To: Joan Frederiksen, BPS West District Liaison
From: Joel Hill
Cc: Mike Saling, Dave Evonuk, Teresa Elliott, Cherri Warnke, Ryan Curren
Date: October 14, 2020
Re: West Portland Town Center Plan District (WPTC) – Water Bureau Deficiency Review

MAP 1B

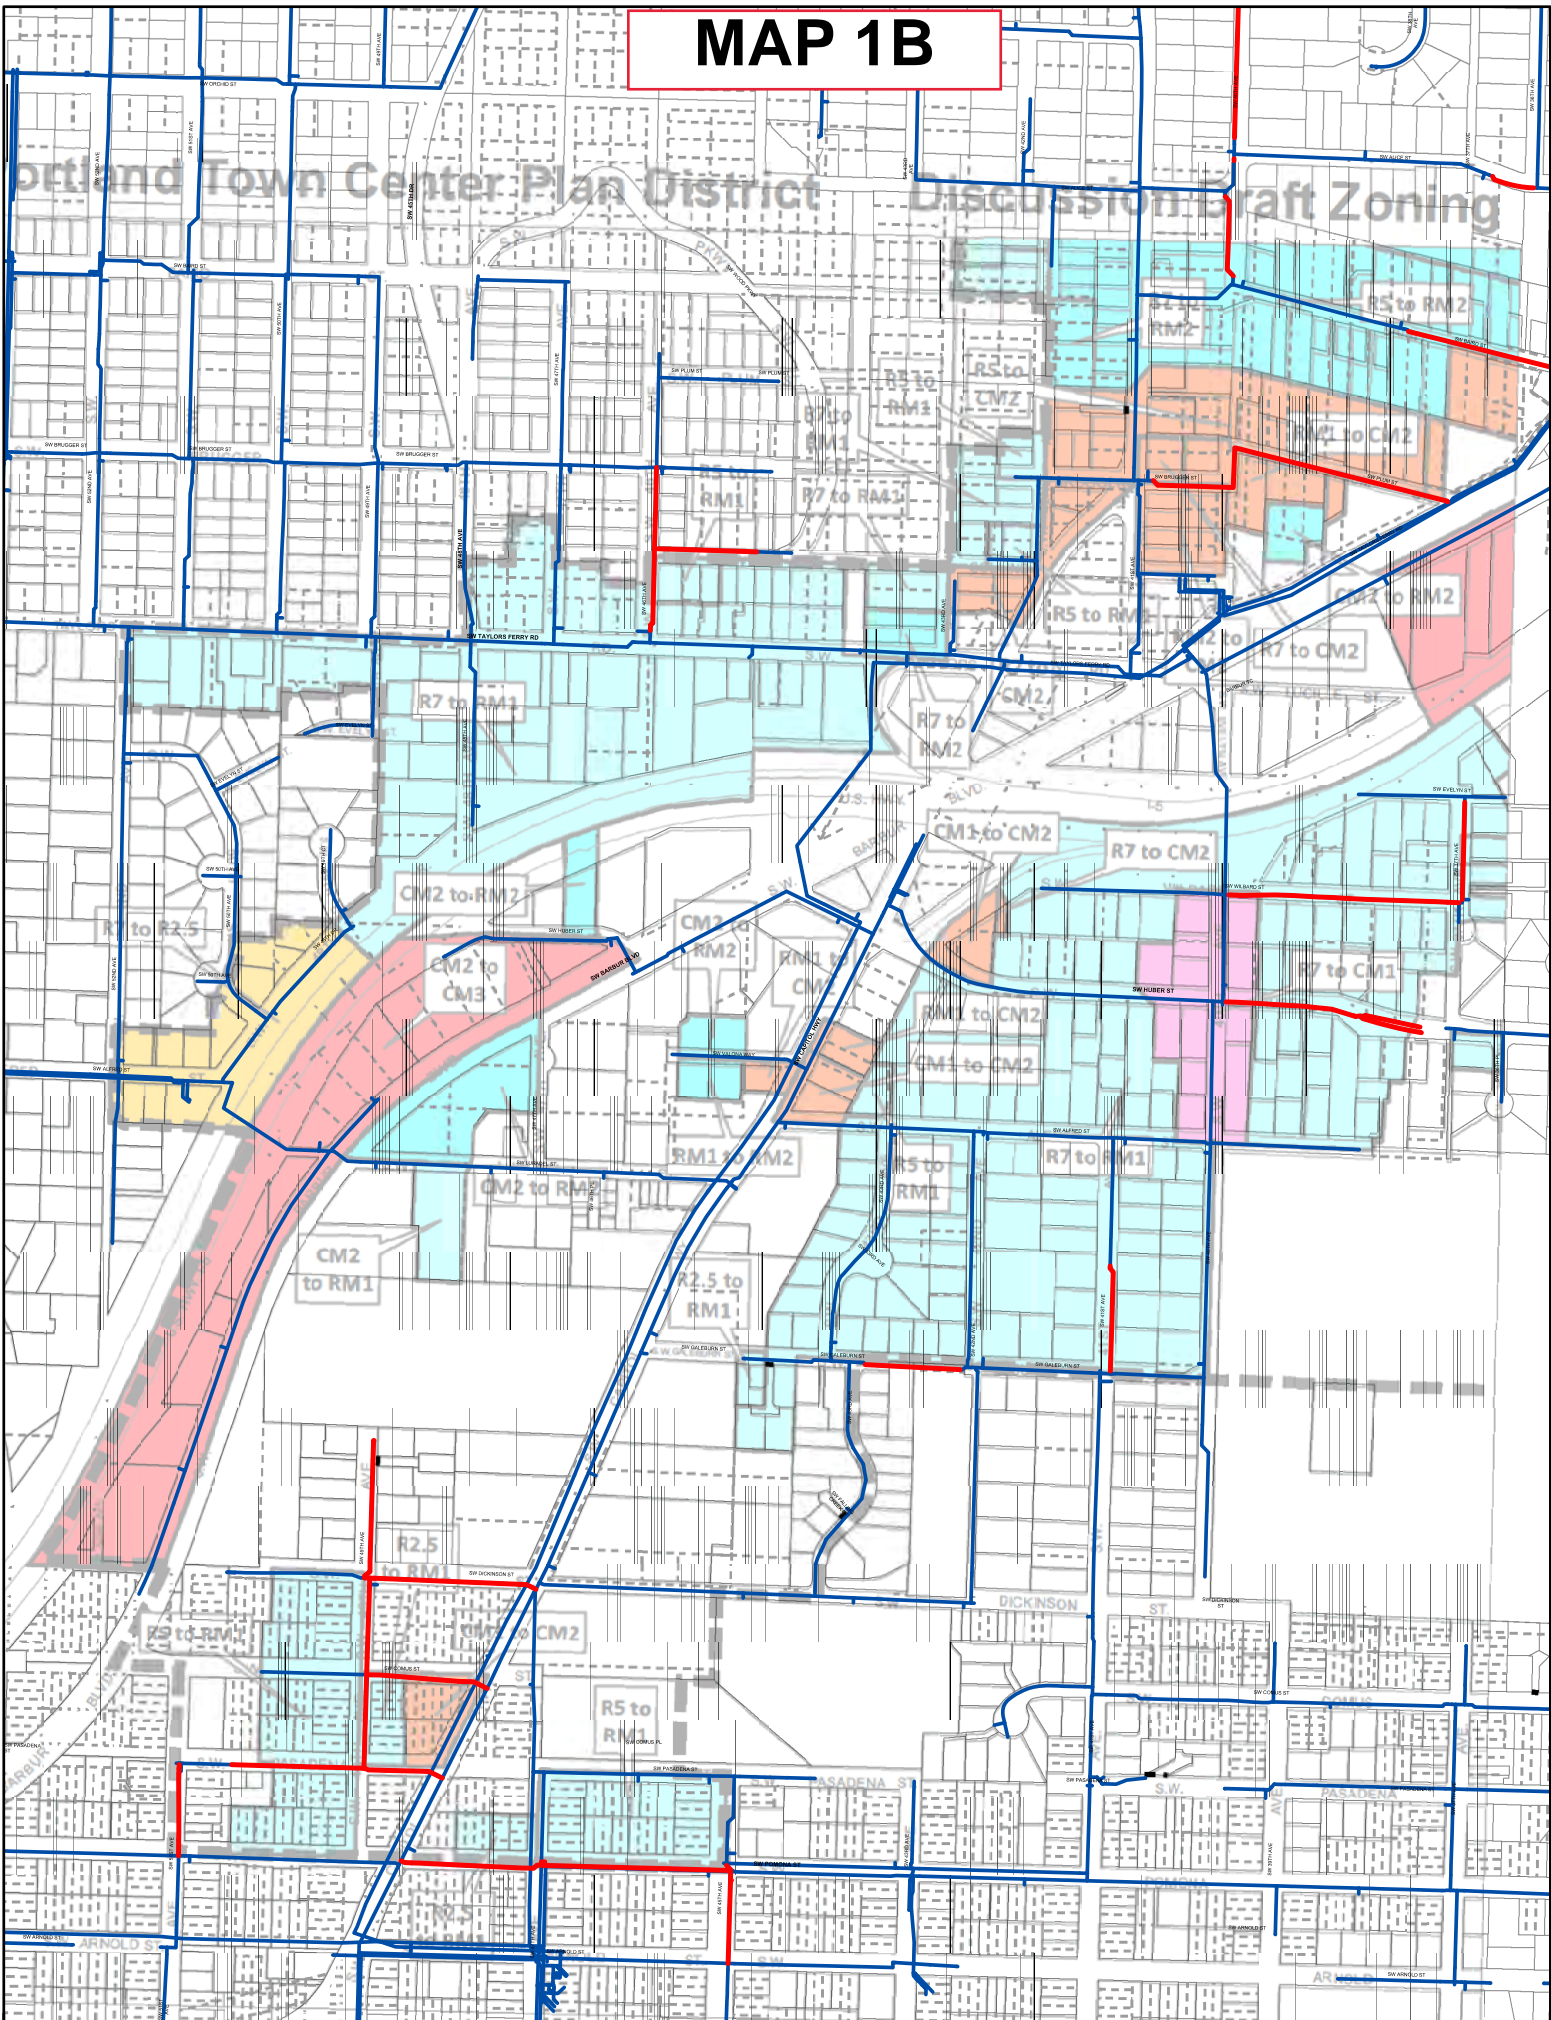
1. Less than 6-inch (non dead-end) Map: There are approximately 14,700 feet of existing undersized mains that do not meet current Water Bureau standards within the WPTC boundary. The PWB minimum size for distribution mains that are non dead-end is 6-inch in non-commercial areas. Hydrants on mains less than 6-inch can rarely provide standard fire flow. *

MAP 3B

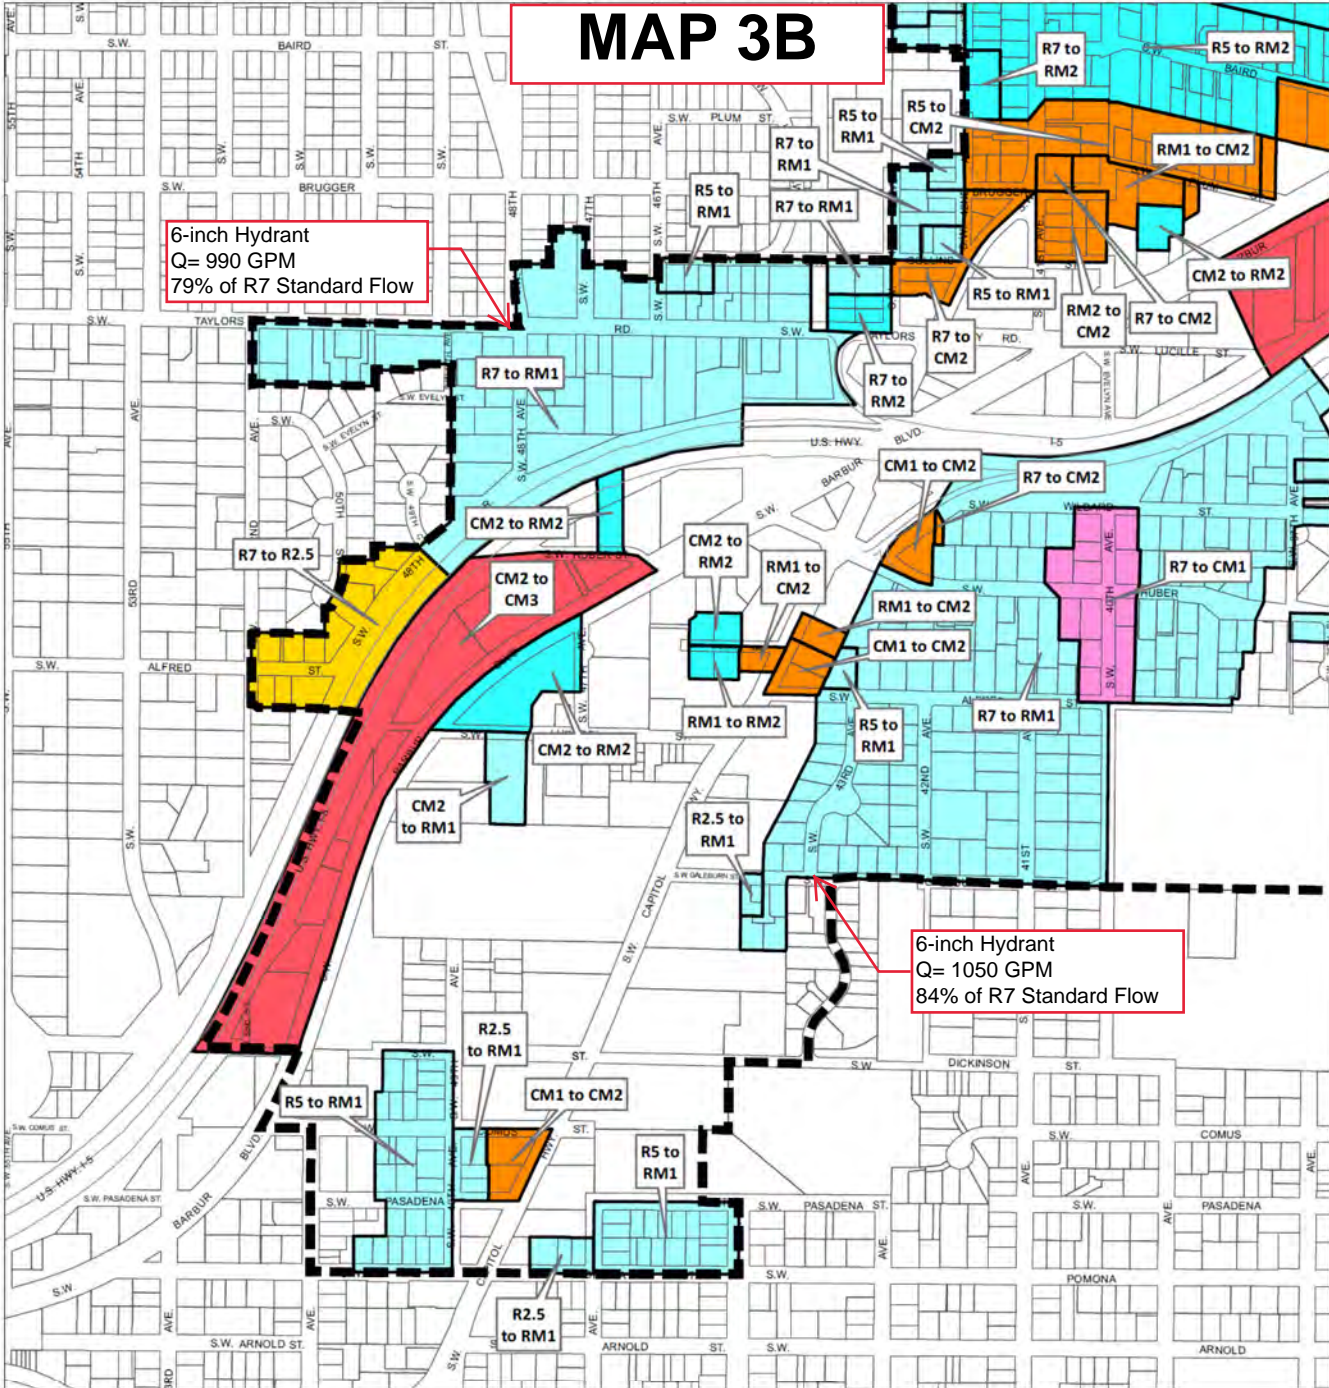
3. Hydrant Flow Map: Three of five hydrants evaluated within the WPTC boundary showed below standard fire flow for the existing single family (R7) zoning. Only a few hydrants were sampled through-out the boundary and a larger modeling effort of more hydrants may be needed to better understand/define the extents of this deficiency. These hydrants were chosen at random, but with the intent to pick ones spread out across the WPTC area. The standard requirement for hydrant flow in a commercial zone is 3500 GPM provided by four hydrants. The four nearest hydrants to SW Brugger and SW 41st have a combined hydrant flow of 2,600 GPM which is only 75% of the standard commercial fire flow.
